**RESPONSE TO COMMENTS  
NPDES PERMIT NO. NH0100790  
KEENE WASTEWATER TREATMENT PLANT  
KEENE, NEW HAMPSHIRE**

In accordance with the provisions of 40 C.F.R. §124.17, this document presents EPA’s responses to comments received on the Draft NPDES Permit # NH0100790 (“Draft Permit”). The Response to Comments explains and supports EPA’s determinations that form the basis of the Final Permit. From May 20, 2020 through July 20, 2020, EPA solicited public comments on the Draft Permit.

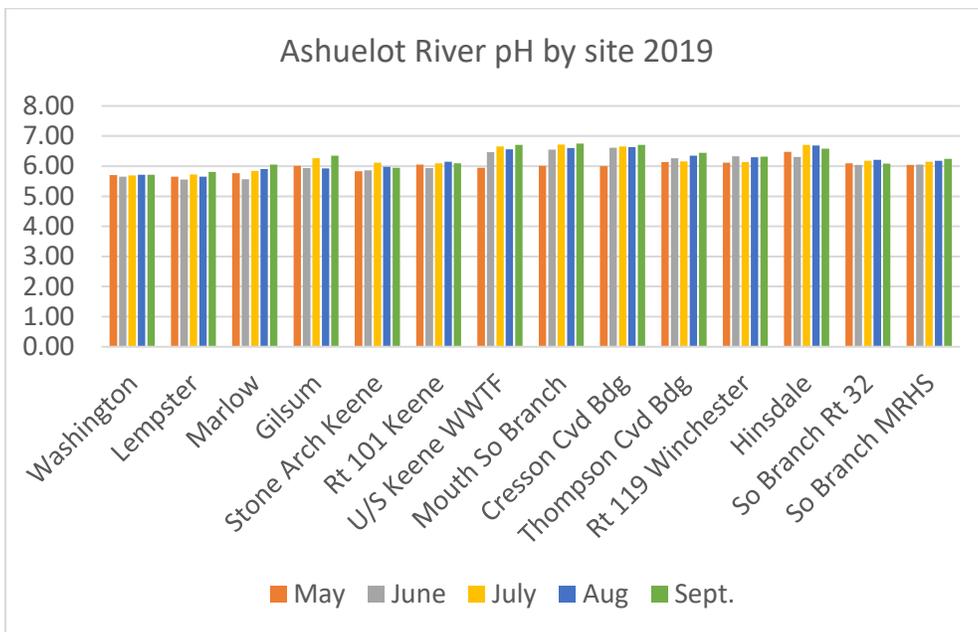
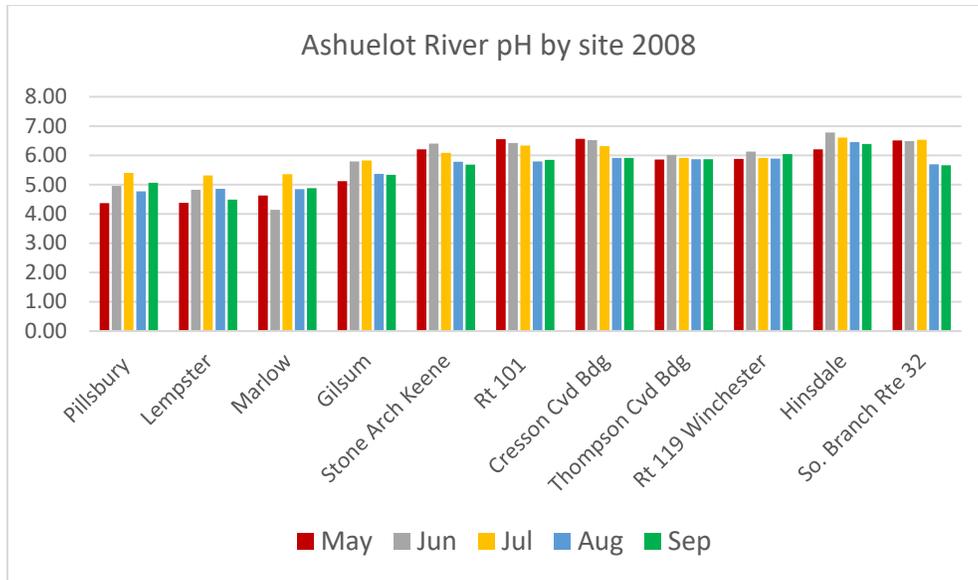
However it is worth noting that NHDES Water Quality Standards (WQS) define levels of 0.026 - 0.049 mg/L as more than desirable. As the chart above shows, there are instances where readings have approached this level. Ideally a lower permit limit would help to achieve this standard.

As described in the Draft Permit, EPA does not have a basis to establish a permit limit more stringent than one based on current WQS. As noted in the Fact Sheet, EPA implemented the state’s narrative nutrient water quality criteria by relying on a range of relevant information, including EPA’s *Gold Book*, which recommended a threshold-based value of 0.1 mg/l. This is intended to be an upper limit not to be exceeded during critical conditions, such as those occurring during low flow (7Q10) and treatment plant design flow. The NHDES has the authority to certify a more stringent limit into the Final Permit based on the range cited in the comment above, if supported by the data and necessary to meet WQS, but has not chosen to do so.

The commenter states that the NHDES WQS define levels (of instream phosphorus) of 0.026 - 0.049 mg/L as more than desirable. EPA believes that the commenter is referring to the NHDES’ 2018 Consolidated Assessment and Listing Methodology (CALM) document, which is not a WQS.<sup>7</sup> In this document, NHDES determined that a waterbody is potentially attaining WQS if there are no dissolved oxygen impairments and the median total phosphorus (instream) concentration is below 50 µg/L based on data collected for the seasonal period of May 24 – September 15 that are five years of age or less (pp. 95-96). This indicator is not intended to assess a surface water as impaired for infrequent or minor occurrences of elevated total phosphorus. NHDES has never used this analytical methodology to determine whether to classify a river or stream in the state as impaired. Rather, this indicator is intended to address more significant and/or chronically elevated total phosphorus levels. EPA notes that New Hampshire has not adopted a numeric total phosphorus criterion into its WQS.
